Staff Report

To: DRAC
From: Justin Mehlhaff, Assistant Planner
Meeting Date: 5/22/23
Report Date: 5/19/23
RE: Grand Teton Floor & Window Covering Warehouse Final Design Review Application (DR22-4)

SUMMARY: The applicant is proposing the development of a 7,895 sf window & flooring showroom and warehouse with off-street parking, on a 1.92 acre property in the Valley Centre subdivision. The property is zoned Commercial Corridor (CC), and is within the Design Review Overlay.

VALLEY CENTRE SUBDIVISION
CONCEPT PLAN

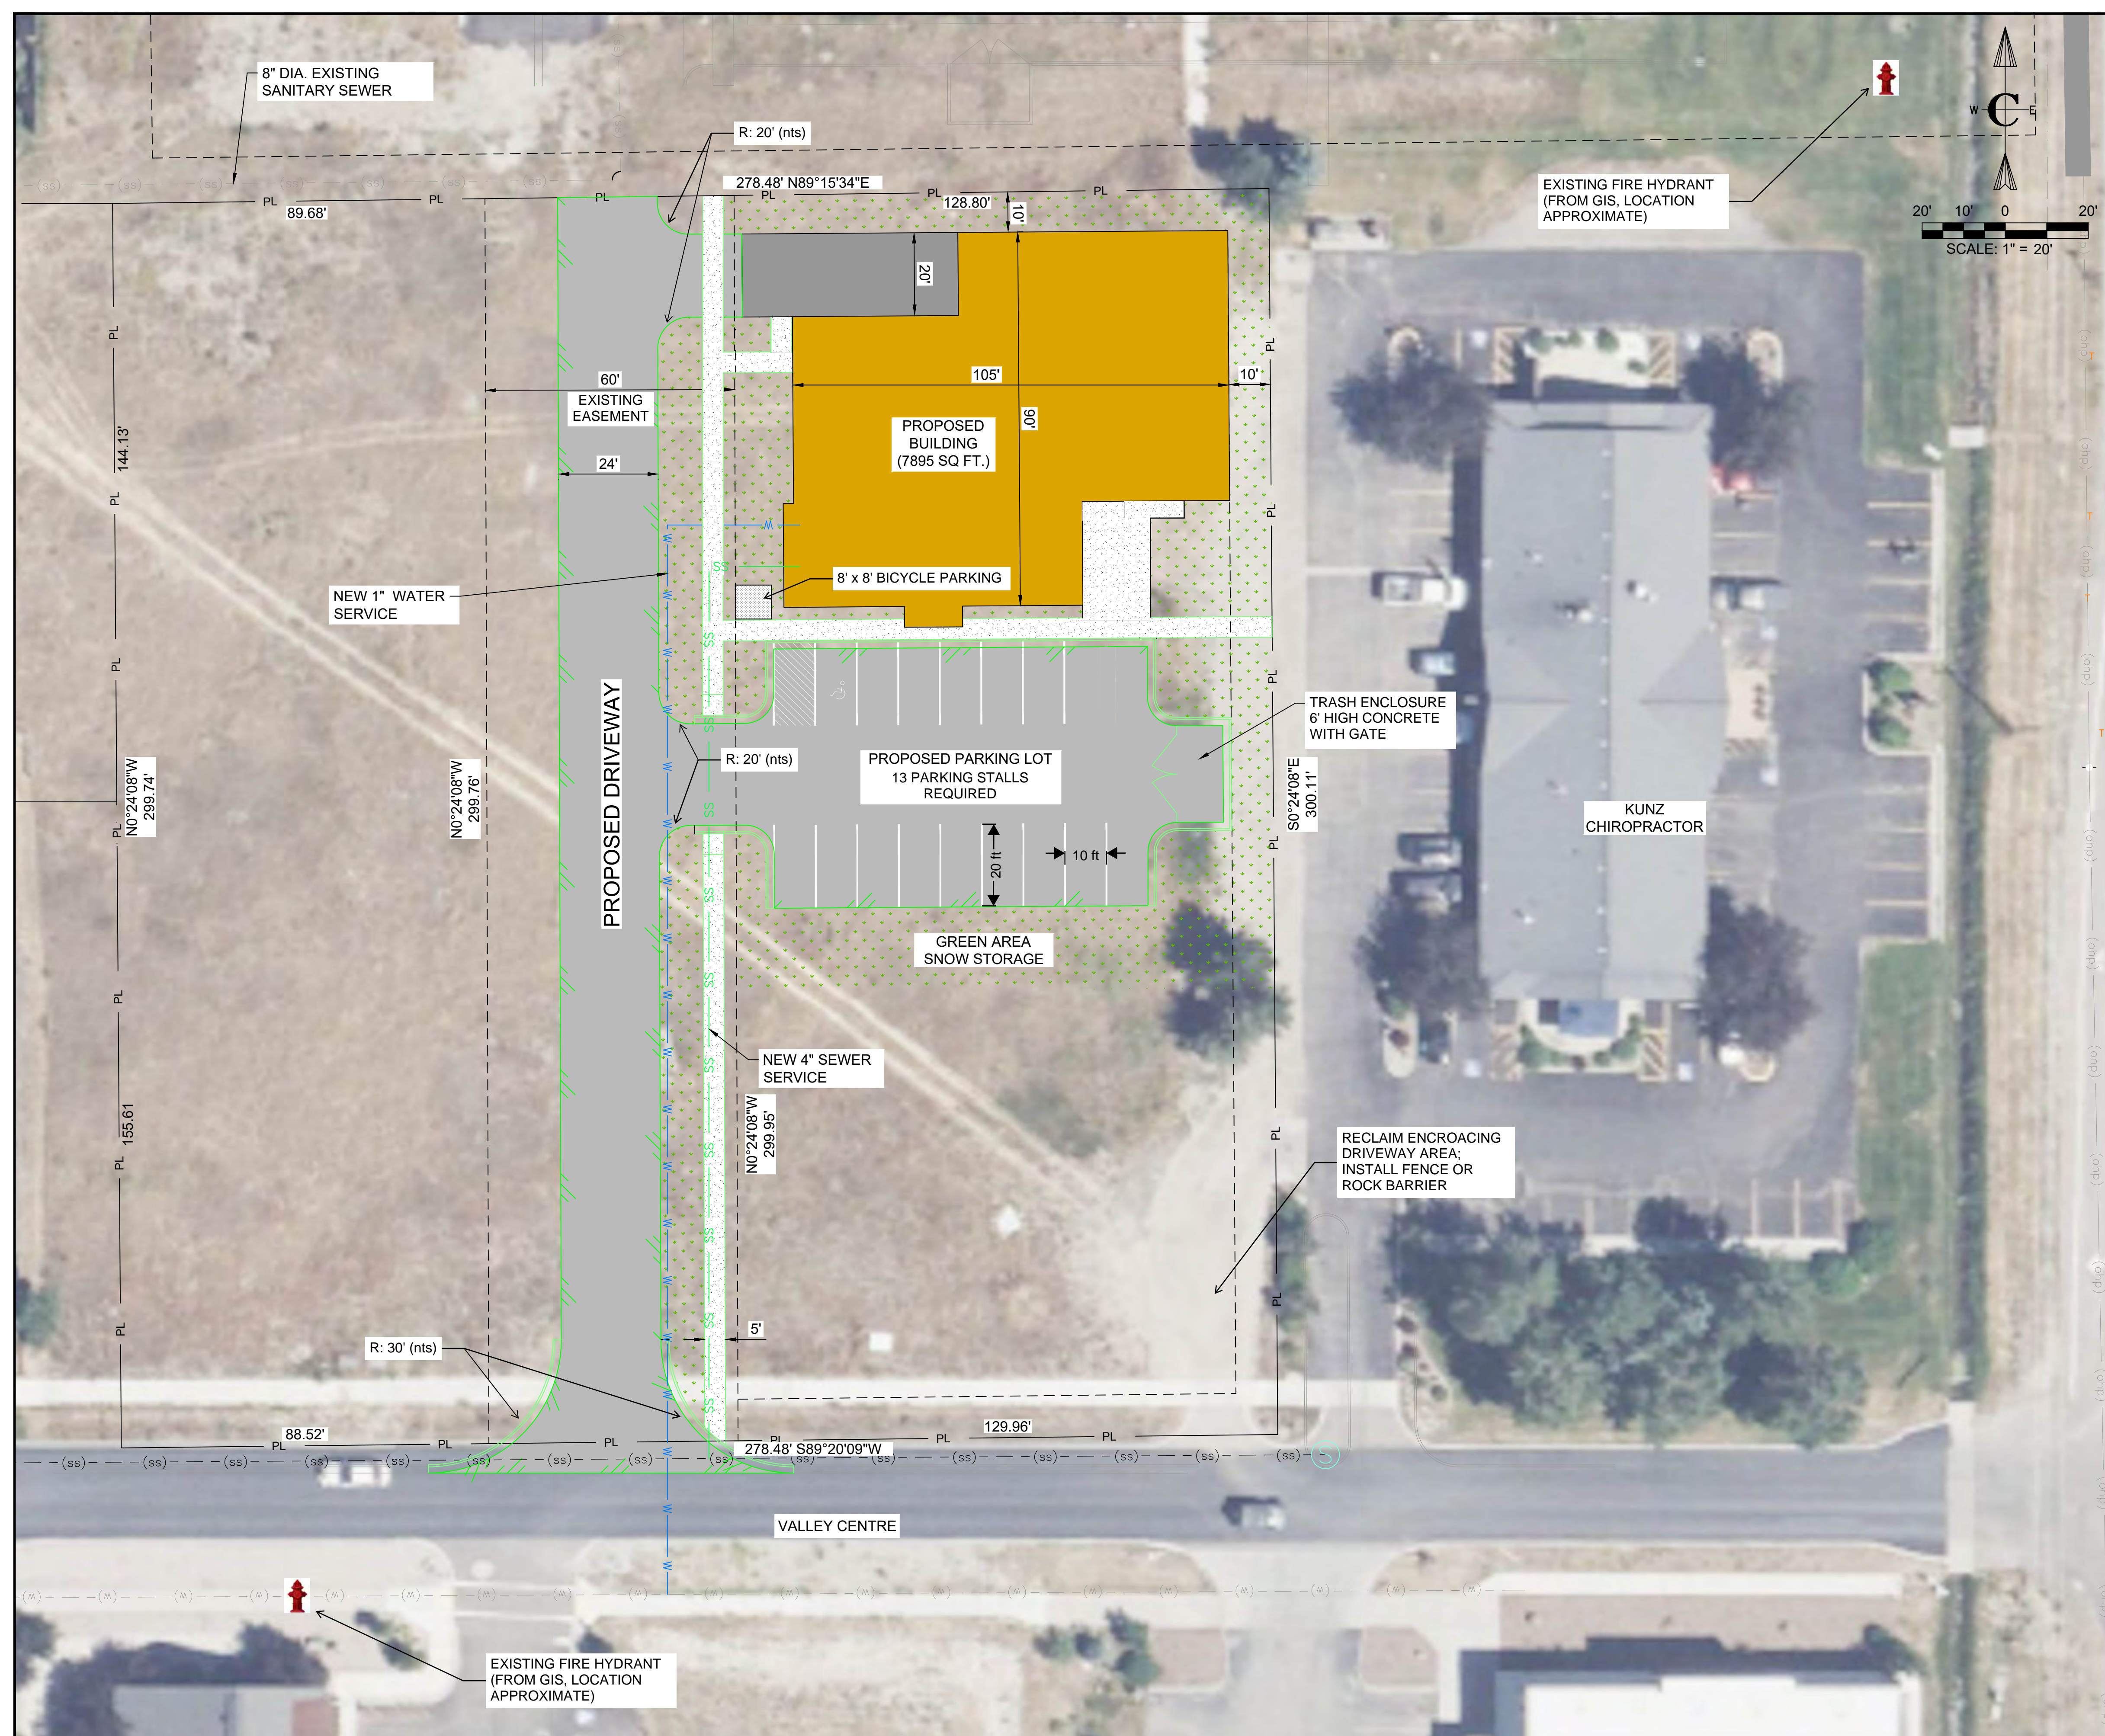
12.1.6 - Easements	Easements must be provided in locations required by the City. All existing easements should be described on the site plan.	60' access & utility easement shown down the middle of the property.	Access easement or pavement must be shifted to the west to line up with accesses to the south (Arrowhead Plaza Way) and the north (drive lane behind ECIDPDA). DRAC to consider. Applicant to provide Instr # for all

existing easements.
12.1.13 – Street layout	<p>B. Streets must be aligned to join with planned or existing streets.</p> <p>C. Street jogs with centerline offsets of less than 125 feet are not allowed.</p>		<p>Current driveway location does not conform. Access easement or proposed pavement must be aligned with Arrowhead Plaza Way and the rear ECIDPDA drive lane.</p> <p>DRAC to consider.</p>

PUBLIC WORKS: *60' ROW should be shifted to the west to align with Arrowhead Plaza Way to the south and driveline to the north. Applicant should consider cross access through parking lot to the development to the east.*

1. **STAFF RECOMMENDATION:** Staff recommends DRAC review the application, consider any necessary conditions, and ultimately make a recommendation of approval. Staff recommends the following conditions:
 - Access easement and/or proposed pavement shall be aligned with Arrowhead Plaza Way and ECIDPDA rear drive lane.

The driveway easement is existing, and as such, the driveway will need to be located within the existing easement. It may be possible to move the proposed driveway west within the easement and line up with Arrowhead Way. We would like the opportunity to discuss this with DRAC.

The sidewalk has been extended to the northern building entrance and to the northern property line.

Bicycle parking has been added near the building entrance.

The existing fire hydrants have been added to the site plan; if the fire department requires an additional hydrant it will be added to the plans prior to building permit submittal.

THE NORTH LOADING BAY IS FOR LARGE DELIVERY VEHICLES.
 THE SOUTH GARAGE DOOR WILL ONLY SERVE STANDARD-SIZE VEHICLES.

Rev.	3/7/2022 1:25:43 PM	Author
ELEVATION		A103
Jim Schulz

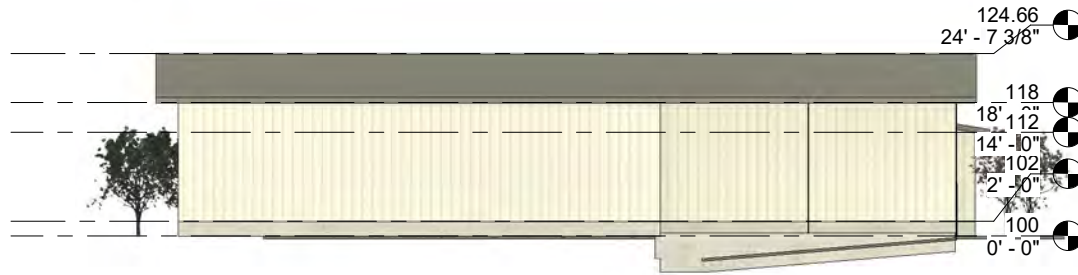
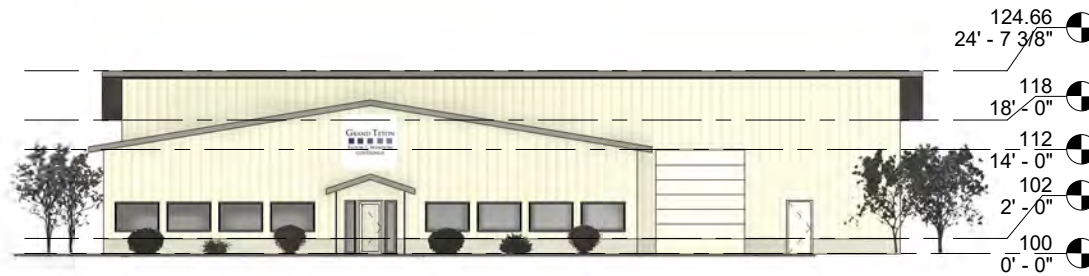
VI.C.3.3.d Buildings and Structures - Windows	Ground floor windows or window displays shall be provided along at least thirty percent (30%) of the building’s ground floor, street-facing elevation(s). Design elements such as large regularly spaced and similarly shaped windows with window trim, transoms and clerestory windows above building entrances are counted; windows and display boxes must be integral to the building design and not mounted to an exterior wall in order to be counted.	Four windows proposed along newly proposed frontage.	Applicant to confirm transparency. DRAC to consider.
VI.C.3.3.f Buildings and Structures – Blank Walls	Notwithstanding the provisions of LDC Chapter 8 Building types, building elevations in the design district shall not have blank walls. This standard is met when the guidelines contained in Figure 13 (“acceptable” illustration) are satisfied and no wall has more than thirty (35) feet of continuous, uninterrupted horizontal distance. All elevations longer than thirty (35) feet shall have offsets; projections (e.g., recessed or covered entrances or weather protection); alcoves; windows or doors; changes in materials, colors, or patterns; volume landscaping to include evergreen and deciduous trees and shrubs that complement the building elevation; or a combination of such changes, providing visual relief not less than once every thirty (35) feet. (Note:	Northern wall contains blank walls exceeding 35 ft.	Applicant should consider features such as windows, changes in materials and colors, and/or additional landscaping along the northern wall to provide for breakup, and all other blank wall areas 35’ or greater. DRAC to consider.

For certain building types, the LDC standard of 25 feet applies.)		
VI.C.3.4 Materials and Colors	<p>Primary materials shall consist of primarily of brick, natural stone, and painted or natural wood. Secondary materials may consist of metals such copper, steel, iron, or bronze, and similar appearance metals may be used.</p> <p>Primary materials that are equal in appearance and durability to those listed may be approved through design review. Materials that are equal in appearance and durability to those in subsection 'a' may be approved through design review. Color schemes should be simple and coordinated over the entire building to establish a sense of overall composition.</p> <p>Color schemes should tie together buildings, signs, furnishings, awnings, canopies and entrances. There shall be no more than one base color for each thirty (30) feet of the front elevation; one base color for the entire front elevation is preferred. Using only one or two accent colors is also preferred, except where precedent exists for using more than two colors with some architectural styles.</p>	Vertically oriented steel exterior siding is proposed for the warehouse, with colors gray and white.	Applicant should consider alternative primary materials or additional design features that would more closely conform to the design standards, such as brick/stone/wood. DRAC to consider.
